Our firm represents Vornado/Charles E. Smith and Gould Property Company, the applicants for the pending Rosslyn Plaza Phased Development Site plan (PDSP) application, which was accepted by the County Manager for processing in **February 2012**.

I am writing to express our serious concerns regarding the initial draft of the Rosslyn Sector Plan that was released on May 7, 2015. This draft continues to advance the notion that the central park space at Rosslyn Plaza should be located on Arlington Ridge Road, a location which we have frequently and consistently communicated to County Leaders and Staff that is neither appropriate nor feasible for the site.

Re: Realize Rosslyn Plan Framework

Comments on Draft Framework 2-24-2014

CURRENT SITE PLAN  
VIEW CORRIDORS

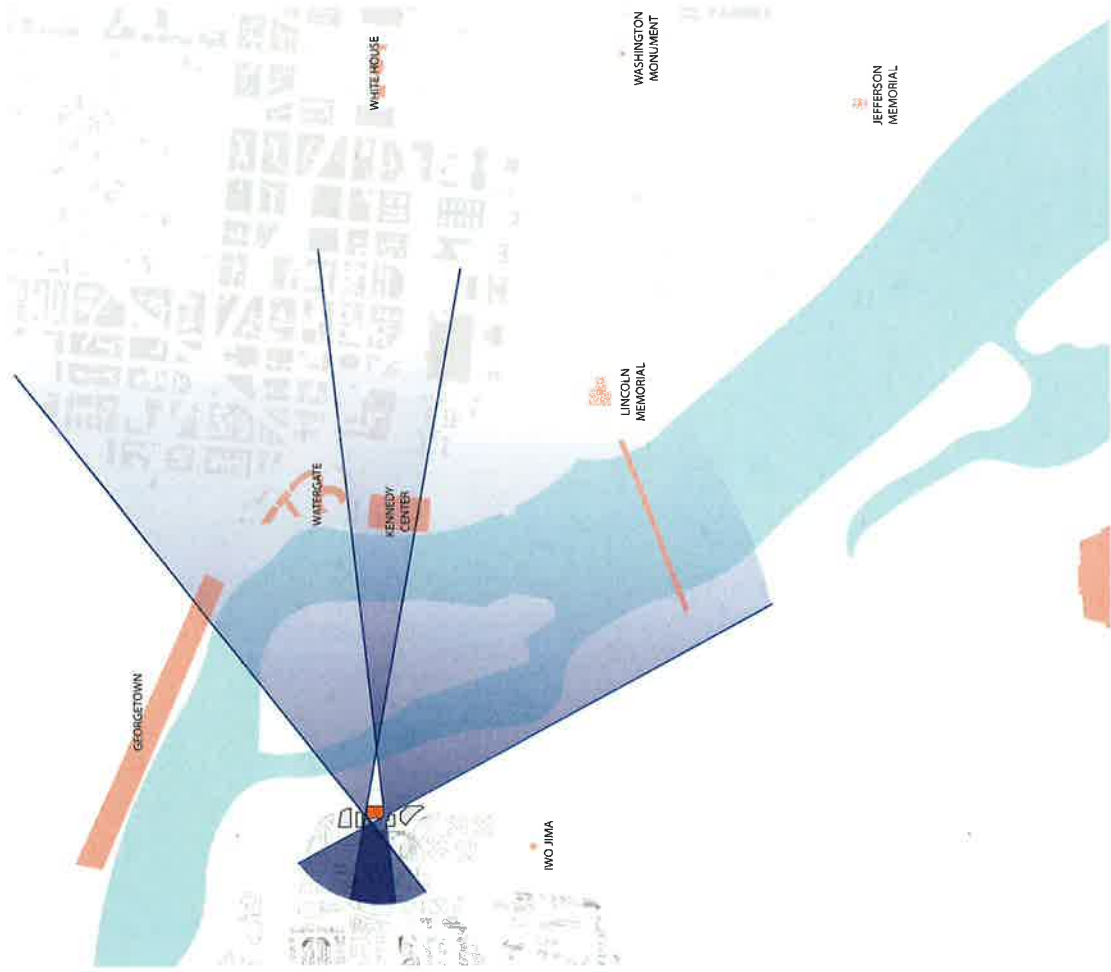
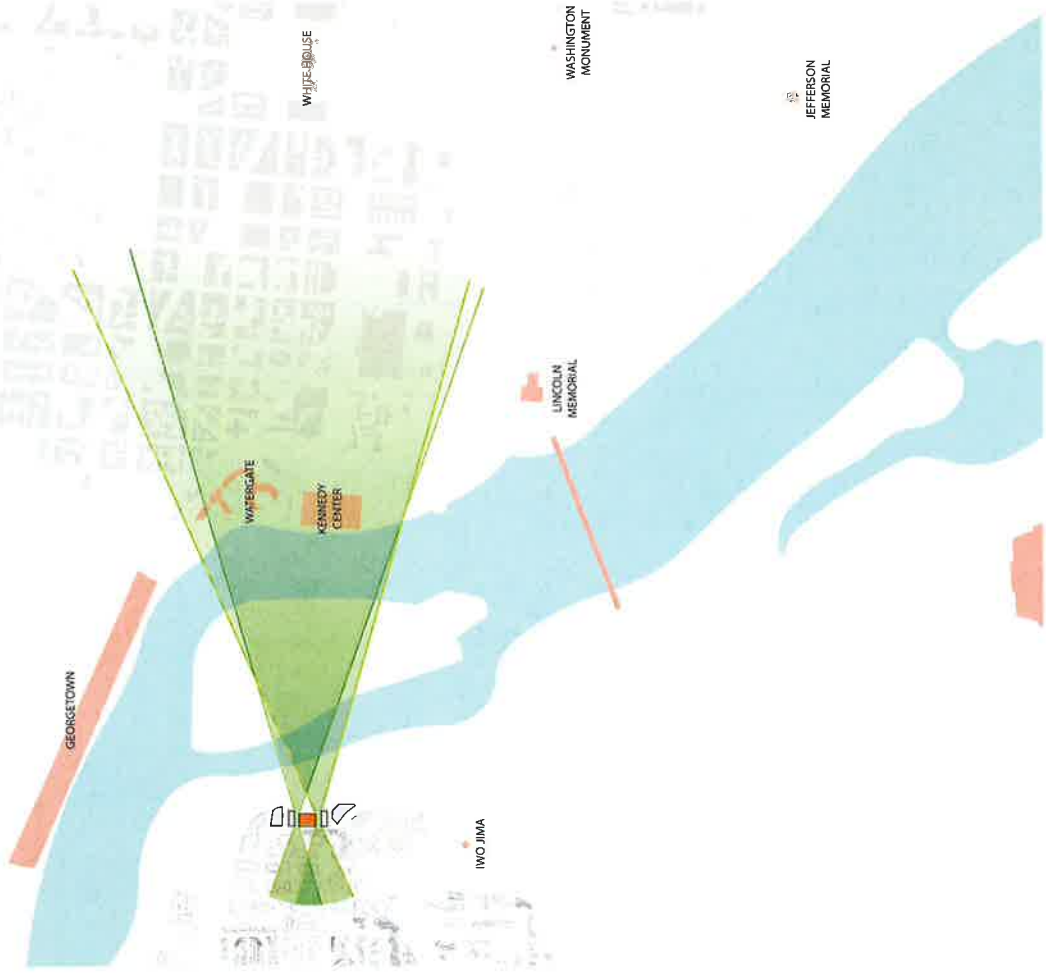
As I stated in my remarks to the Board last night, our current site plan layout and park configuration for the Rosslyn Plaza PDSP, a copy of which is attached, has been carefully designed with staggered building placement to maximize views through and within the site. The attached exhibit demonstrates how such placement dramatically widens the view corridor between the core of Rosslyn and the Monumental core to the south and east. By contrast, a consolidated park on Arlington Ridge, as shown in the current Framework draft, would preclude this staggering and result in a much narrower view corridor.

In addition to achieving the view corridor goal, our proposed layout and park configuration creates a "front door" to Rosslyn Plaza that greets the core of Rosslyn rather than presents a sheer wall of buildings. The proposed central plaza provides over an acre of new open space with varied park spaces that are appropriately sized to support a sustainable and vibrant mix of retail while still creating opportunities for both active and passive recreational uses. They are also connected visually and can be programmed in a manner that invites users through

**Attachment**  
**Preliminary Design Concepts for Redevelopment of 1400 Wilson Blvd**

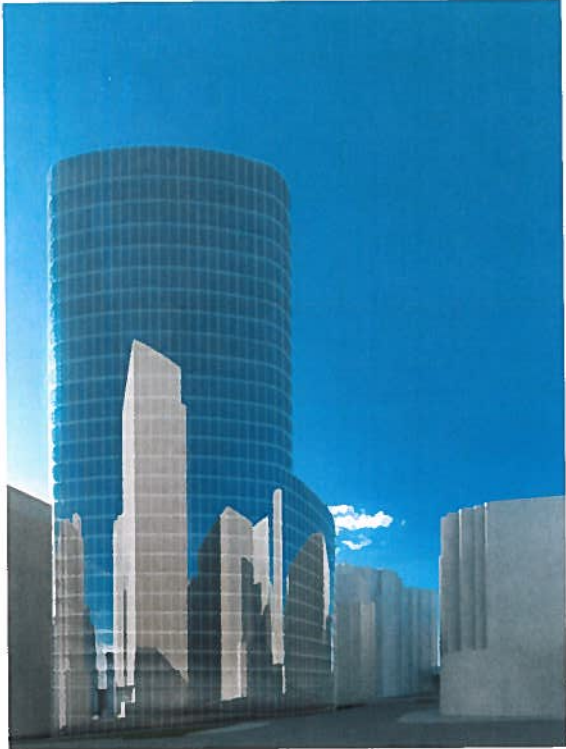
We have met with staff to explain our vision for the property, which may include replacing the existing office building with a new Class A high-rise tower. While this new tower could be an office use, we believe there is also great potential for a mixed use residential tower that might include a hotel use. As you are likely aware, the existing office building was constructed in 1966 and does not have a compelling street presence, nor does it create a very welcoming environment for pedestrians. As shown in the pictures below, loading and trash services are currently located on Wilson Boulevard, and parking access is provided on 17<sup>th</sup> Street North. No sidewalk is provided on 17<sup>th</sup> Street North.

To help us create a new vision for 1400 Wilson, we engaged the award-winning architectural firm of Pei Cobb Freed & Partners (PCF), whose local projects include the United States Air Force Memorial in Arlington as well as Potomac Tower and Waterview in Rosslyn. As shown on the attached drawings, PCF has conceptualized an elegant and sophisticated urban design language capable of accommodating a single or mixed use building, with a vastly improved ground plane experience oriented to the pedestrian and an elegant tower structure above. Such a building could also help achieve a major goal of the Rosslyn Sector Plan -- to correct the historic imbalance between residential and office uses in Rosslyn. However, achieving an economically viable density with the slender profile and marketable floor plates required for such a building will be difficult, if not impossible, if the height is limited to only 260 feet. The unintended consequence of this height reduction is that we are much more likely to keep the existing building in place.
